RE: Pacific Trust
21450 Mission Blvd.
Hayward CA 94541
REQUEST FOR SITE CLOSURE

Re: Request for Case Closure, 21450 Mission Blvd., Alameda County
(unincorporated), CA

Subject: Response to ACHCSA Comments Regarding UST Closure Report,
Hayward Motors, 21450 Mission Blvd., Alameda County, CA

Plate
2

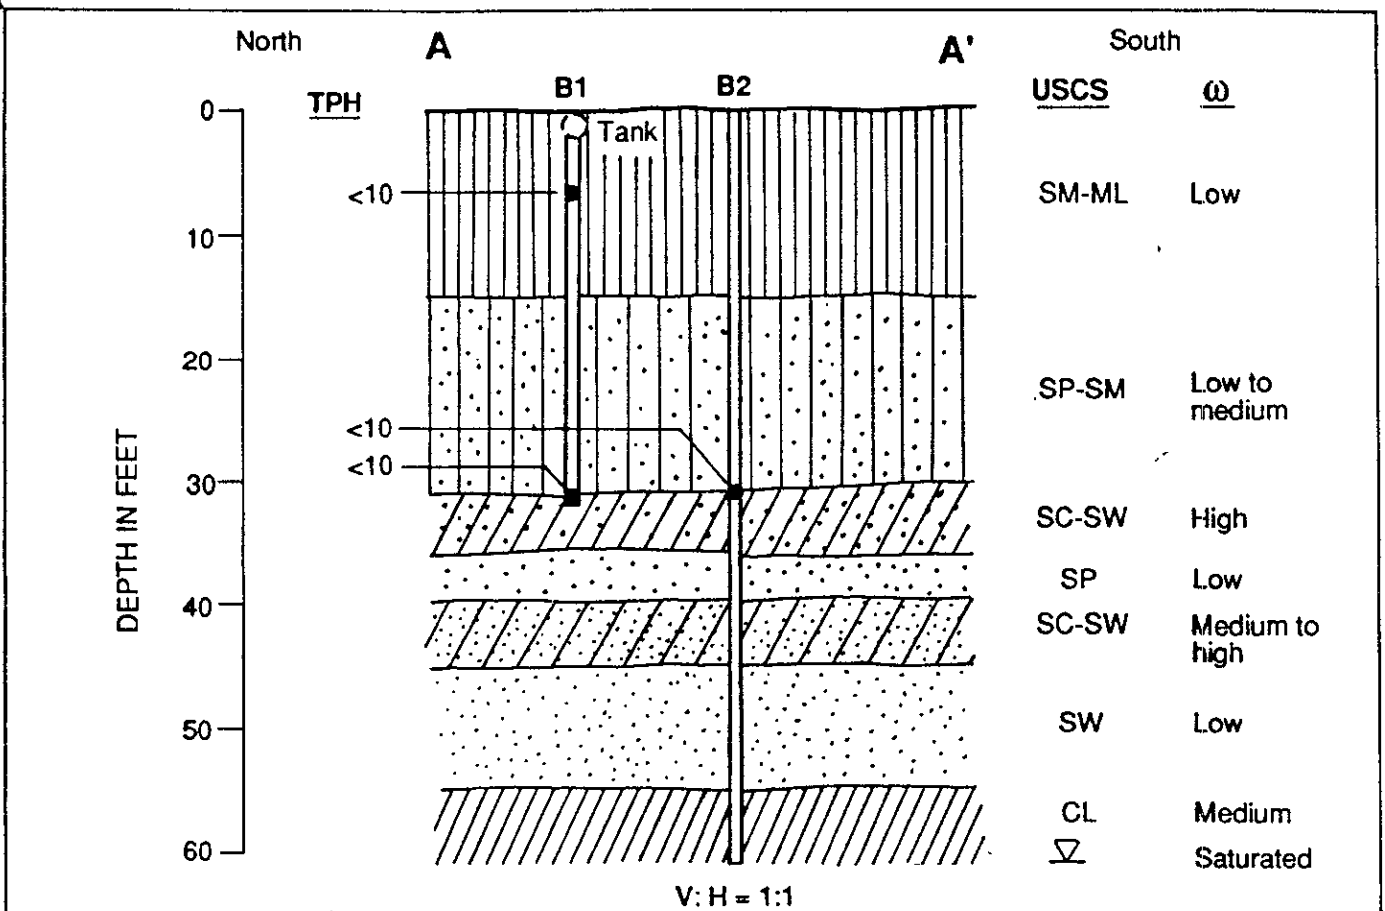
We are very pleased to inform you that both of these conditions have been met: 1) the hydrogeologic setting, illustrated in Figure 2 of the EIRRA report dated 14 June, 1991 and incorporated herein as Attachment A by reference, has illustrated that the site is underlain by a five foot thick clay aquitard, beneath which first encountered groundwater within a confined aquifer is present with a piezometric surface higher than the confining horizon; and 2) the deepest known contamination at 27 feet, as verified by the presence of nondetectable concentrations at 30 feet from two separate boreholes, overlies first detected groundwater at a depth of 61 feet by a vertical separation of 34 feet.

Boring log data from your site does not document the presence of a five foot thick aquitard between soil contamination and groundwater, whether it occurs at 30 or 60 feet. In fact, log data indicates that soils on your site are permeable. Also, assuming that the zone of near-saturation found to occur at about 30 feet at your site is not, even in non-drought conditions, actually a perched aquifer, and that the groundwater level at the site is, in fact, at about 60 feet, it has not been demonstrated that a 20 foot separation exists between last known contamination (currently 73 ppm at 27') and groundwater.

KER-6-2

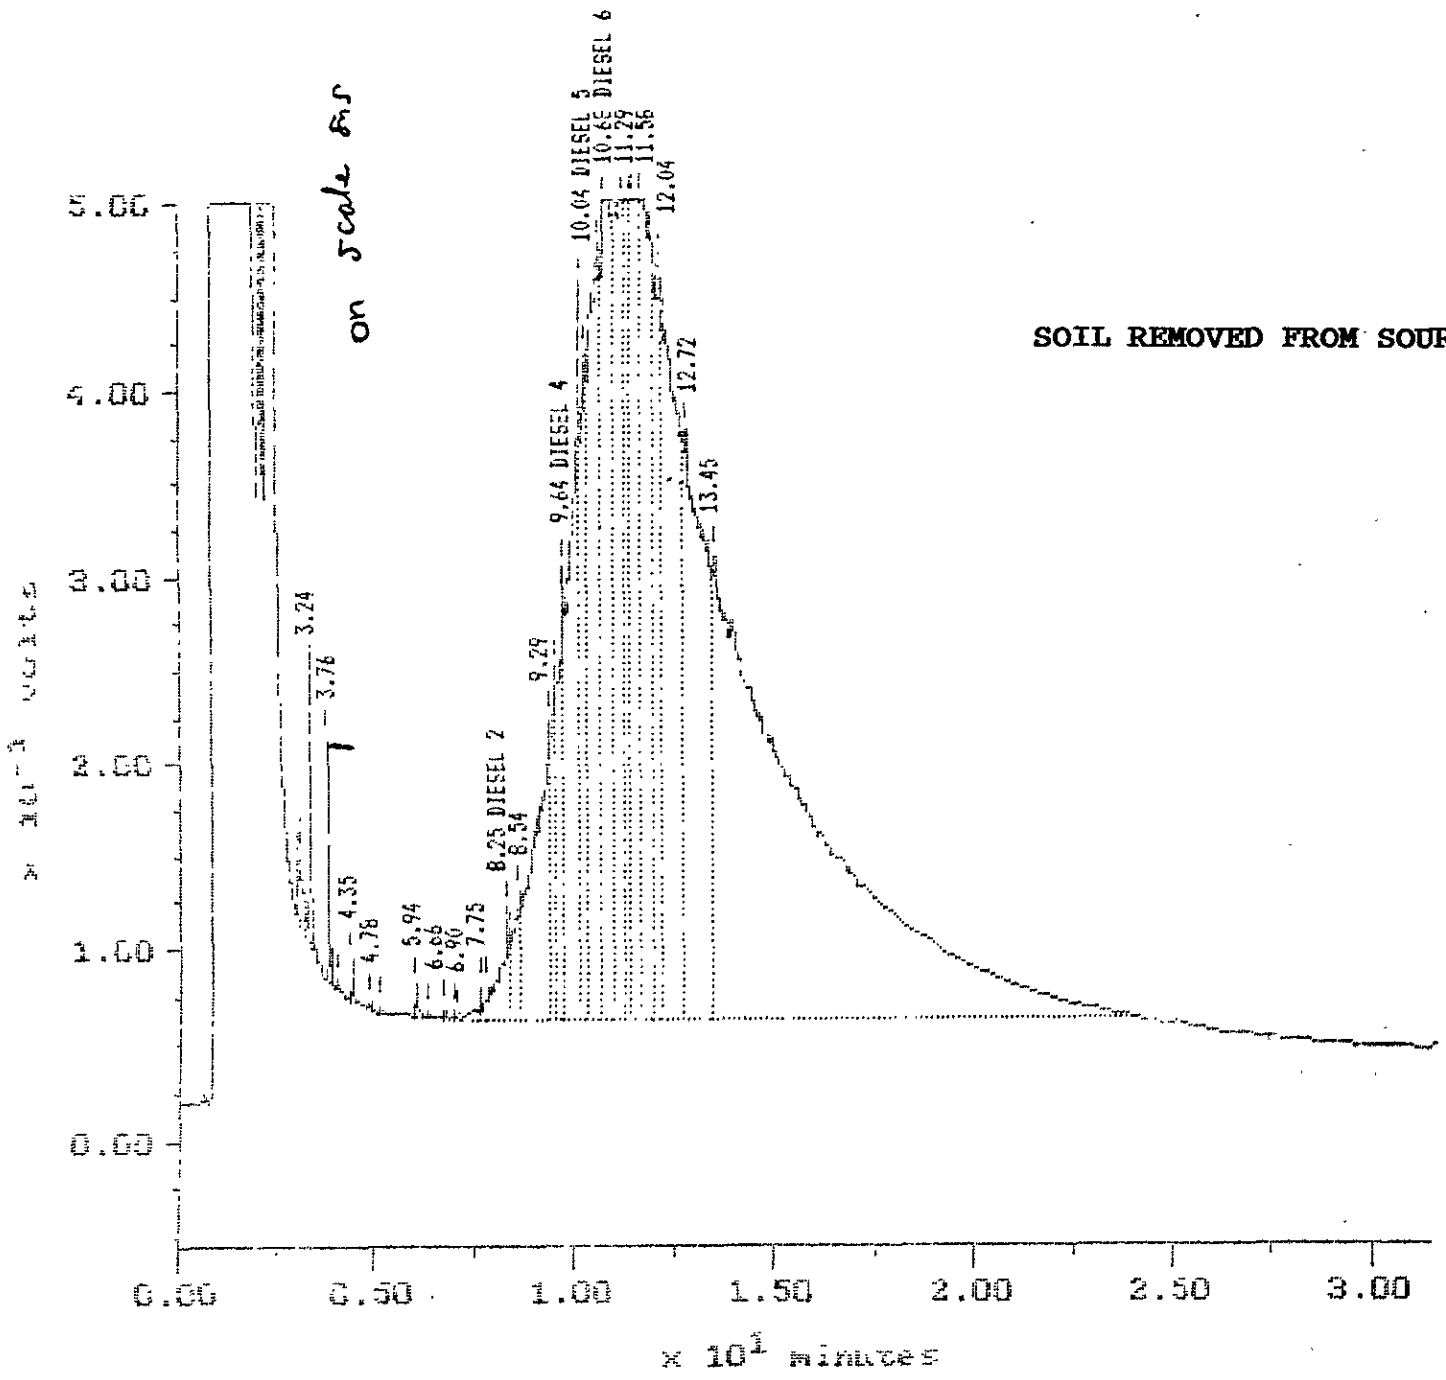
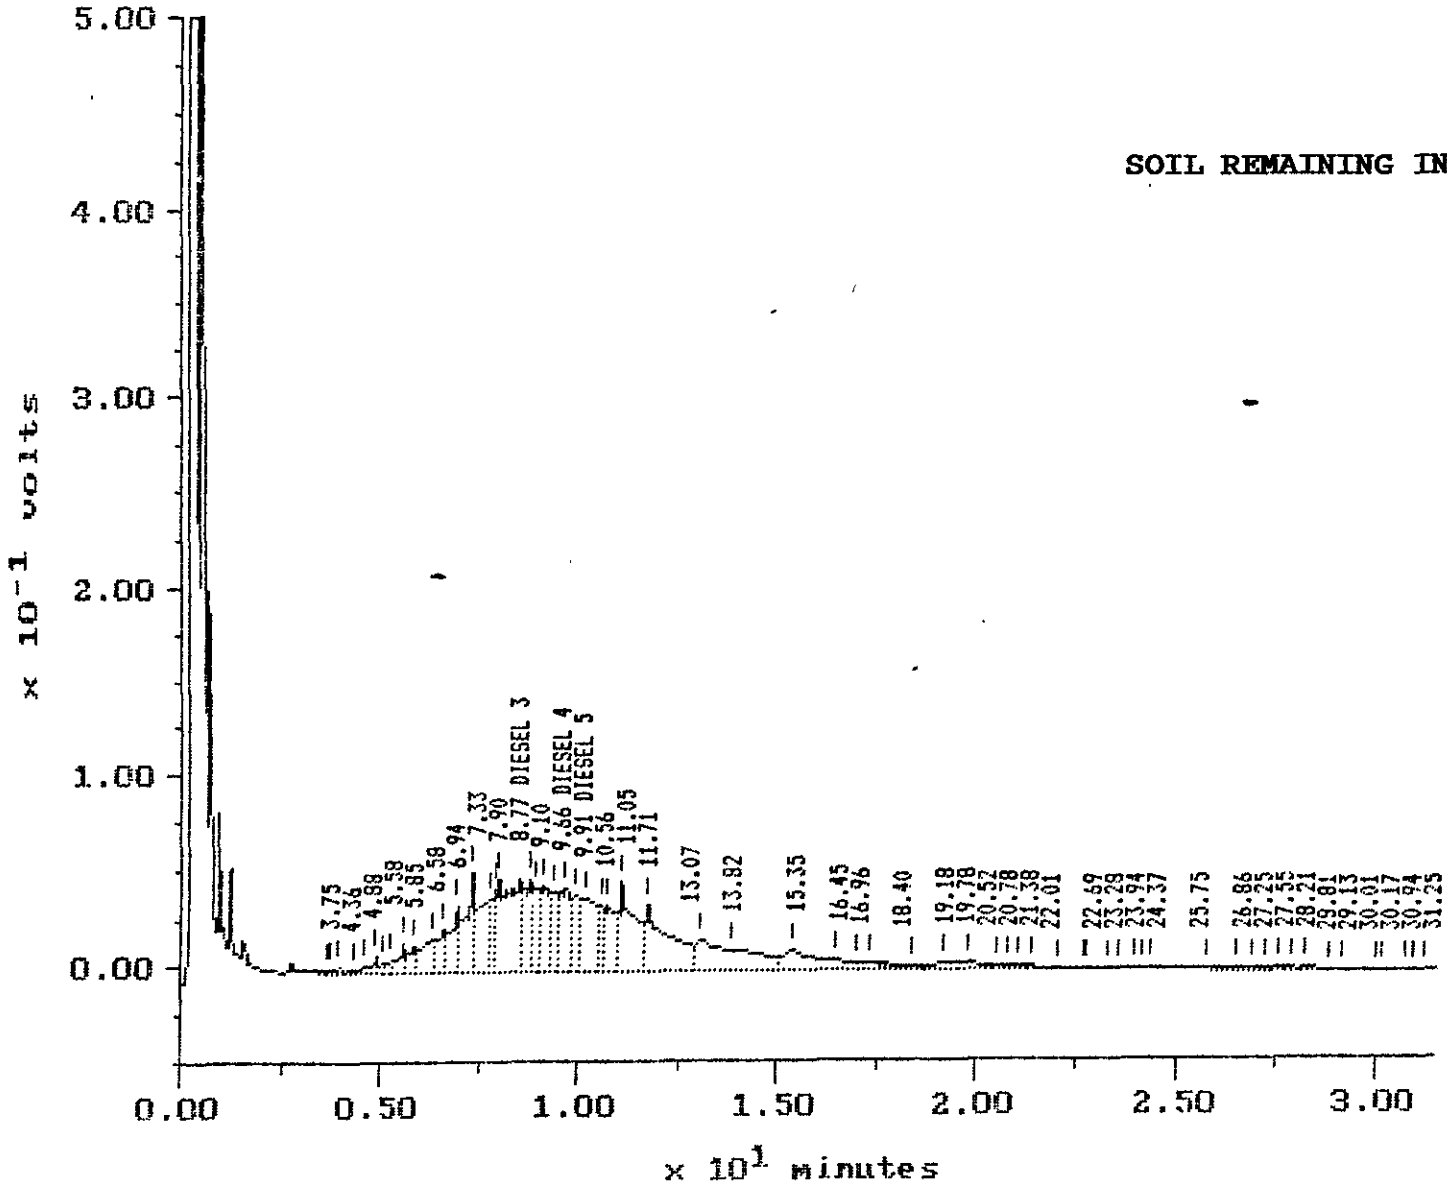
The very strong chromatographic response is derived from soil which has been removed from the source. The very low response is derived from soil remaining in place at the base of the excavation. As you can see, the comparison in peak areas for soil removed from the source area to that residual amount remaining in place clearly shows a very dramatic decrease in contaminant concentrations.
